TOWN OF WATERBURY ZONING PERMIT APPLICATION

Physical location of project (E911 address): TBD Perry Hill Rd.
Lot # 400-2382
 Lot size: 12 acres Zoning District: 1200ft ringeline / conservation
 Existing Use: undeveloped Proposed Use: single family home
 Brief description of project: new construction of 3600sqft
single family residence

**Statement of Billy Vigdor
To the Waterbury Development Review Board (DRB)
Regarding Application 49-21
July 7, 2021 (corrected version)**

#049-21: Elizabeth Brown and Clarke Colon

A3.1

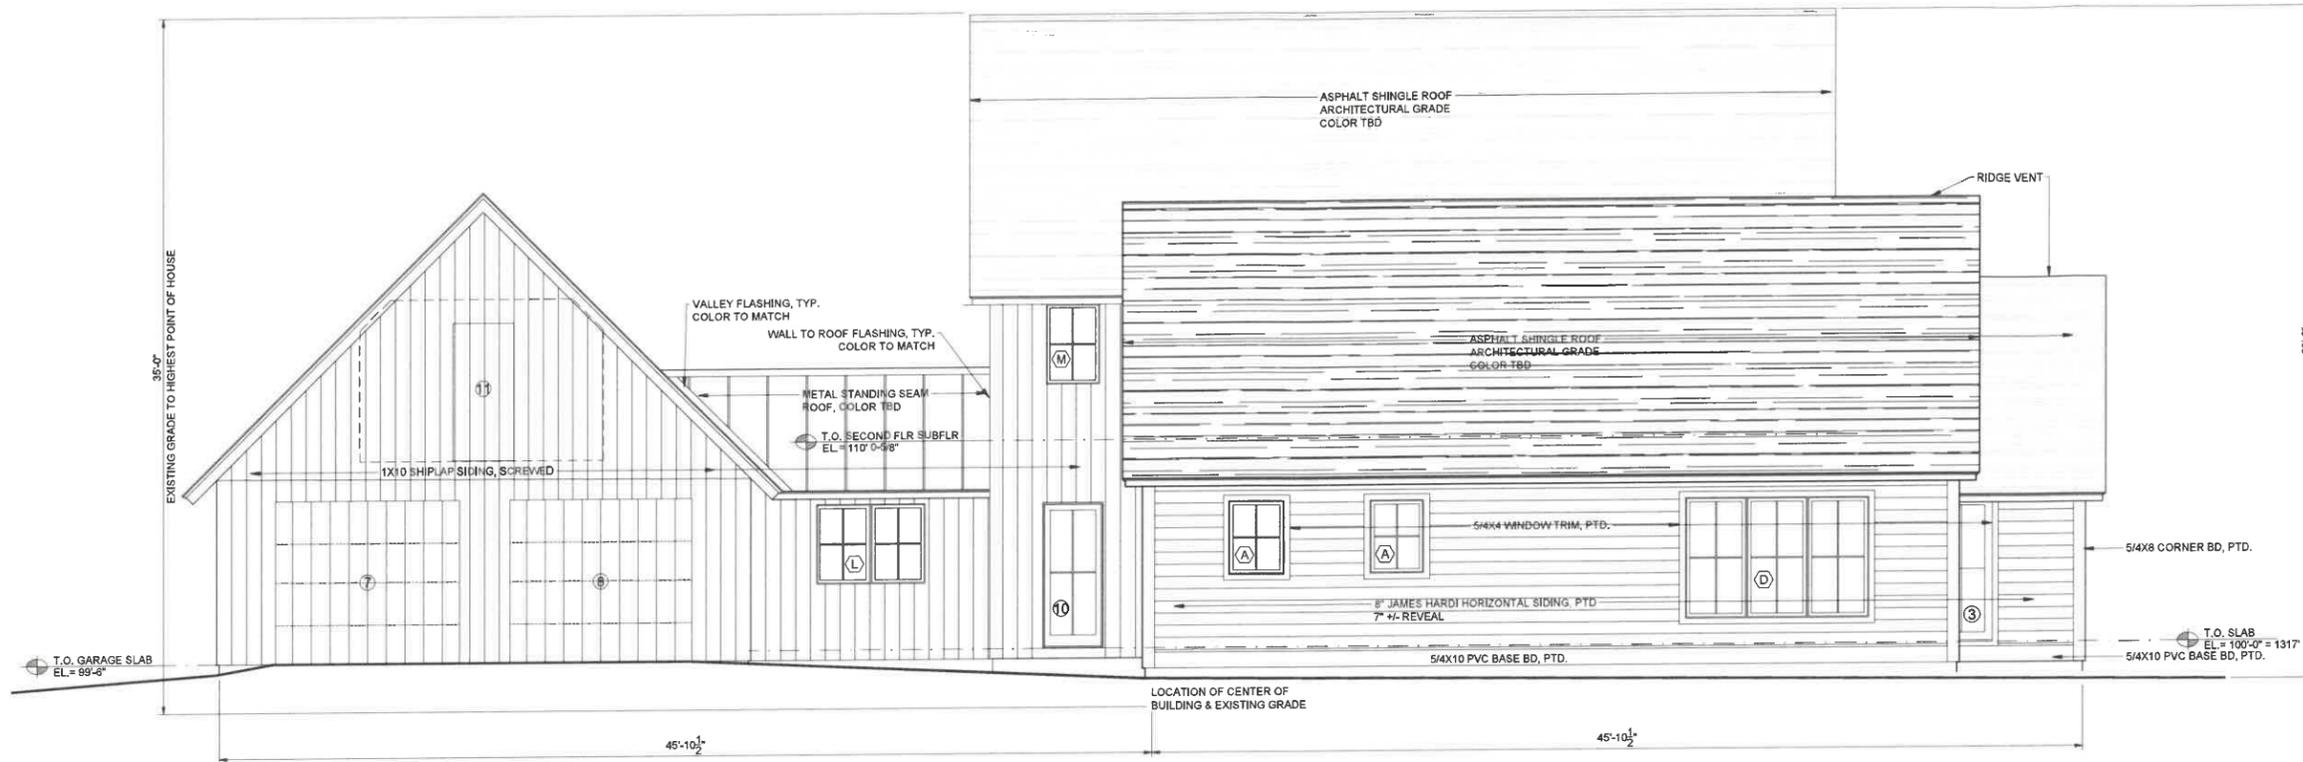
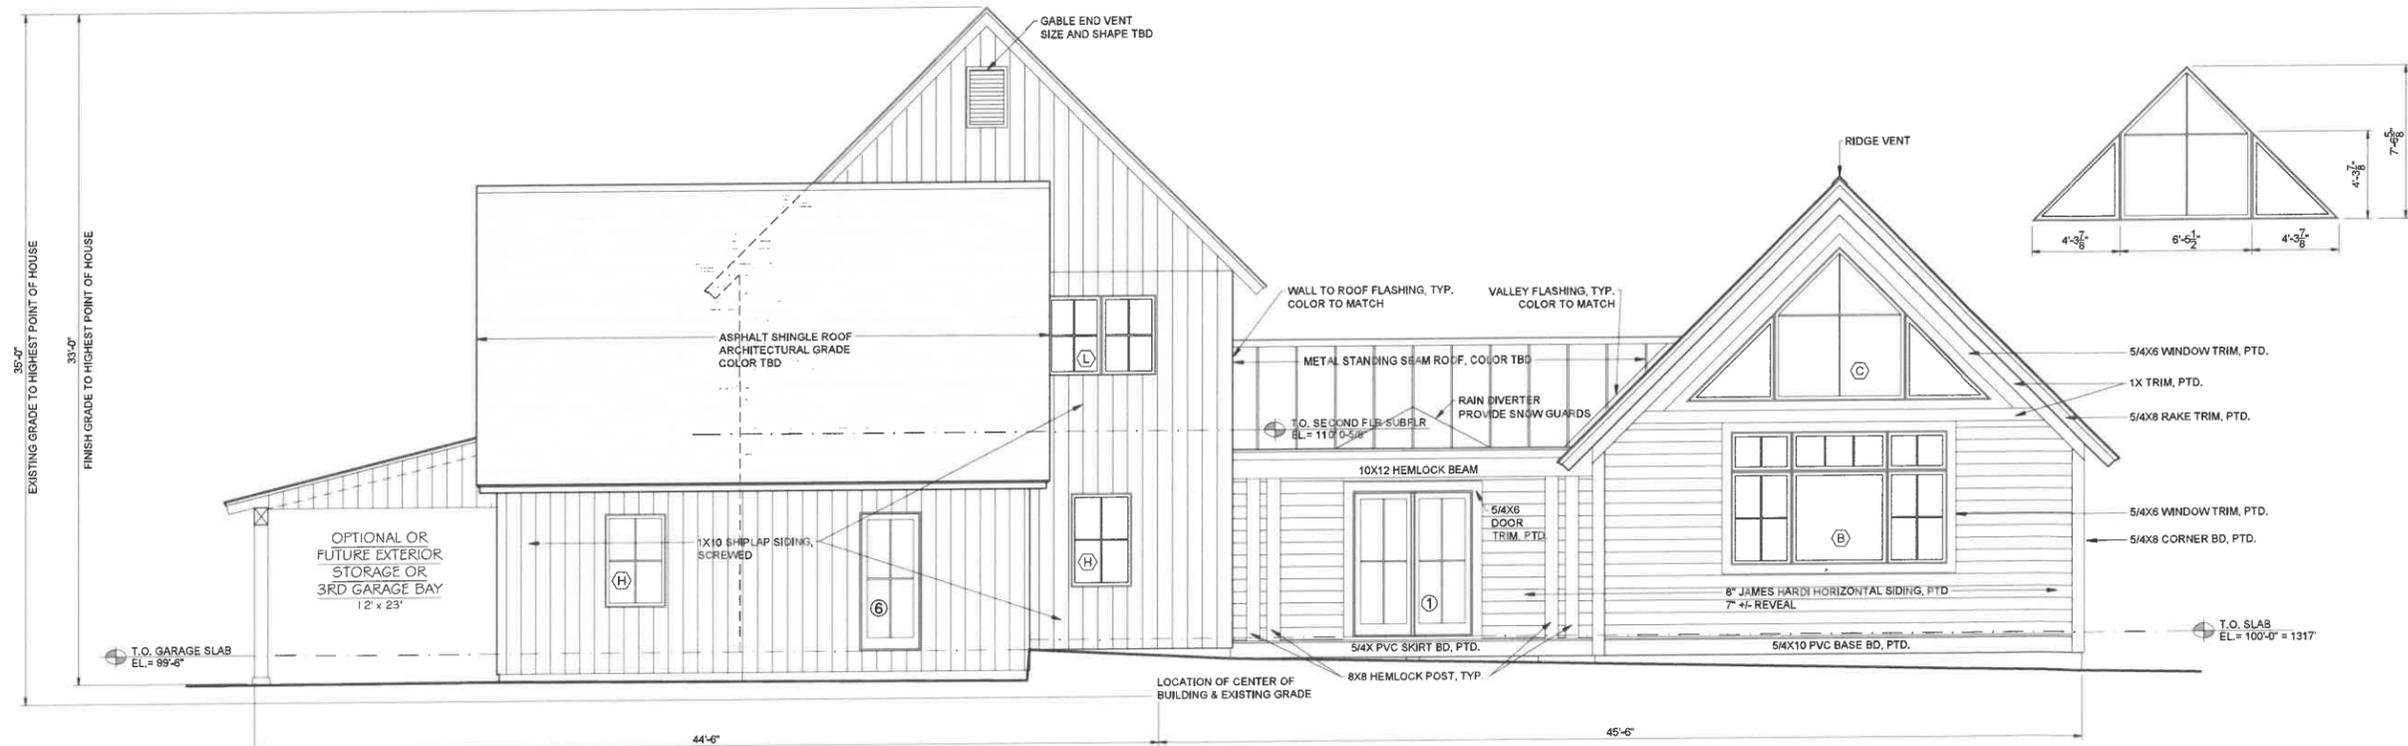
REVISIONS
07/06/21: BUILDING HEIGHT INFO FOR PERMIT

Excerpt, App's SP (L-7)
Not actual ZZ
(Staff mark-up)

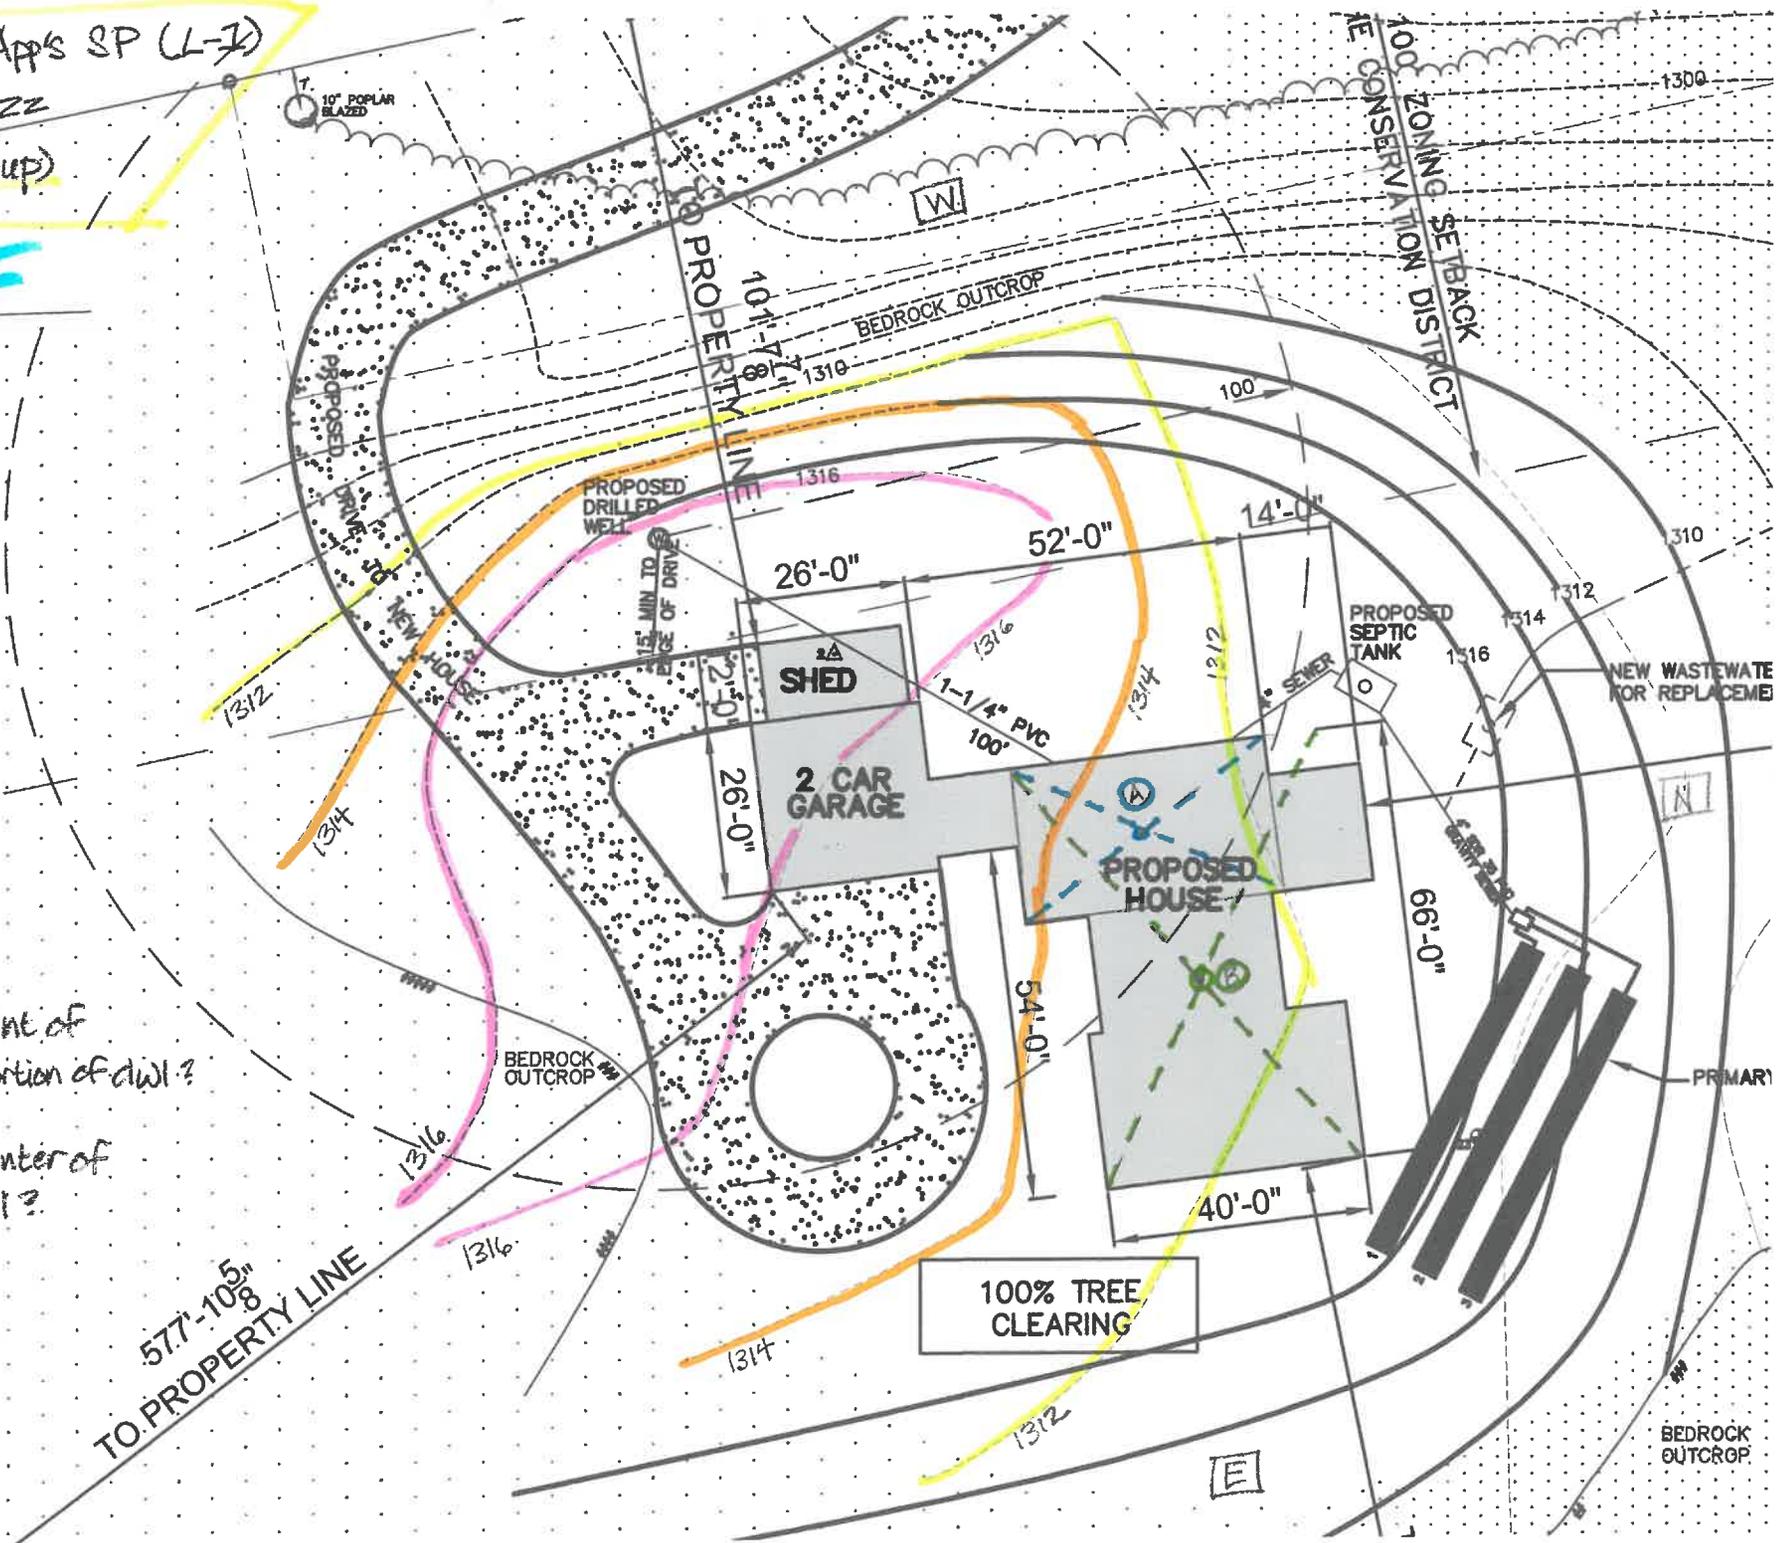
- (A) Center-point of highest portion of dwl?
- (B) Approx. center of entire dwl?
